City of Salmon Arm **Development and Planning Services Committee**

Monday, April 7, 2025, 8:00 a.m. Council Chambers of City Hall 500 – 2 Avenue NE, Salmon Arm, BC

Title: Development Variance Permit Application No. VP-612 (Servicing)

Subject: 370 – 20th Street SE - PLR file number 24.04 Variance Request

EXISTING STORM MAIN

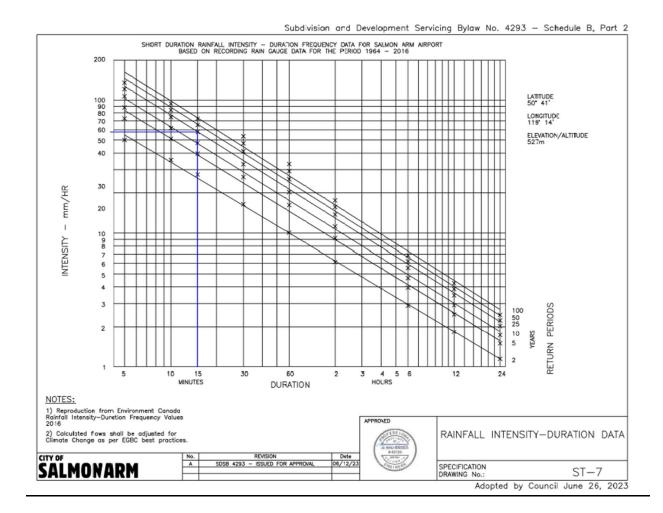
- 2) It is in LELs opinion that, due to location and topography, the existing 200mm storm main is of sufficient capacity to accommodate runoff from the 25 year storm event. The existing 200mm main is approximately 45m in length and currently services a combined catchment area of approximately 1 hectare. As the subject main is located at the top of a local highpoint and in a developed residential area, limited potential exists for dramatic increase in impermeable area. LEL performed flow calculations as per the City of Salmon Arm Bylaw 4293 demonstrating that under the current, fully developed site conditions, the existing main has the capacity to service the entire catchment area without need for current or future upgrades. Under existing conditions, a Tc value of 15 minutes, a 25 year rainfall intensity of 58 mm/hr + 10%, a runoff coefficient of 0.55, and a catchment area of 0.95 hectares were used to calculate a total 25 year runoff rate of approximately 93 L/sec. the existing pipe was then reviewed for capacity. With an estimated slope of 8%, a Mannings n value of 0.011, and pipes flowing at 75% full, the existing 200mm storm main has the capacity to convey approximately 100 L/sec, exceeding the anticipated 25 year run off. For the reasons listed above it is in LELs opinion that the existing storm main does not require upgrades to function as intended and that cash-in-lieu payment for future upgrades of the existing storm main should be eliminated as a condition of subdivision.

The Engineering Department does not support the request to waive the upgrade of the storm sewer main along the east portion of the subject parcel. This storm main is 200mm in diameter, and an upgrade to 250mm is required. As this is premature, a cash in lieu payment for the future upgrade would be acceptable. As calculations show that potential storm events in combination with maximum upstream development potential would exceed the capacity of the existing 200mm main. The alternative motion contained in this Staff Report has been crafted to achieve this recommendation.

EXISTING SANITARY MAIN

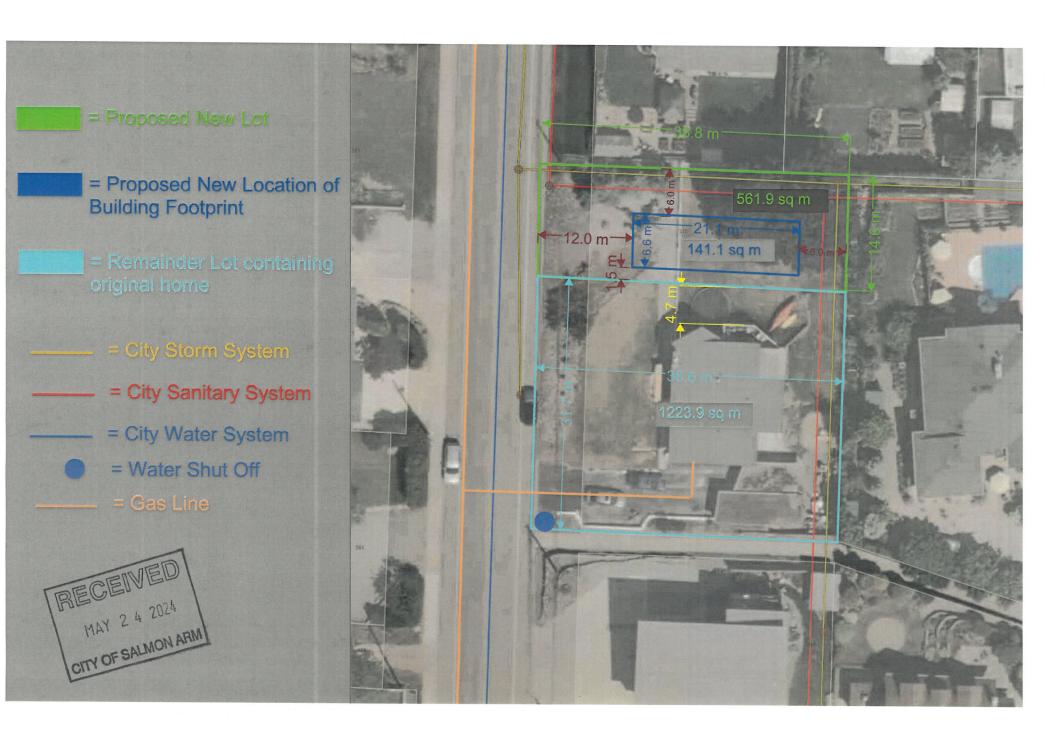
- 1) It is in LELs opinion that the existing 150mm sanitary main is of sufficient capacity to accommodate all existing development as well as any potential future development to be serviced. The existing 150mm main is approximately 45m in length and currently services 11 low density single family homes. As the subject main is located at the top of a local high point, no potential exists for future expansion of its catchment area. LEL performed flow calculations as per the City of Salmon Arm Bylaw 4293 demonstrating that, under both existing conditions, and a proposed future scenario in which the population of each lot is doubled due to the passing of provincial housing bills 44 and 47, the existing main has the capacity to service its entire catchment area without need for current or future upgrades. Under current conditions, with 11 lots at 3.3 people per lot and an average dry weather flow rate (ADWF) of 450L/person/day, total ADWF was calculated to be 0.19 L/sec. A peaking factor of 4.34 was then applied with an Infiltration rate of 0.1 L/sec/ha over a total catchment area of 0.93ha resulting in a total peak wet weather flow rate (PWWF) of **0.91 L/sec** under existing conditions. Under assumed future conditions occupancy was doubled for each of the existing 11 serviced lots for a total calculated ADWF of 0.38 L/sec. A peaking factor of 4.28 was then applied along with Infiltration resulting in a total PWWF of 1.71 L/sec. The above calculated PWWF's were then reviewed against existing pipe capacity. Assuming a Mannings n value of 0.011, a minimum grade of 1.0% as stipulated in City of Salmon Arm Bylaw, and pipes flowing at 75% full, the existing 150mm main has the capacity to convey 16 L/sec, or roughly 10 times to calculated PWWF with a projected doubling of population density. For the reasons listed above it is in LELs opinion that the existing sanitary main does not require upgrades to function as intended and that upgrading of the existing sanitary main should be eliminated as a condition of subdivision.

The Engineering Department supports the request to waive the upgrade of the east sanitary sewer main, as calculations show the existing main can convey future flow for maximum development potential at this location.
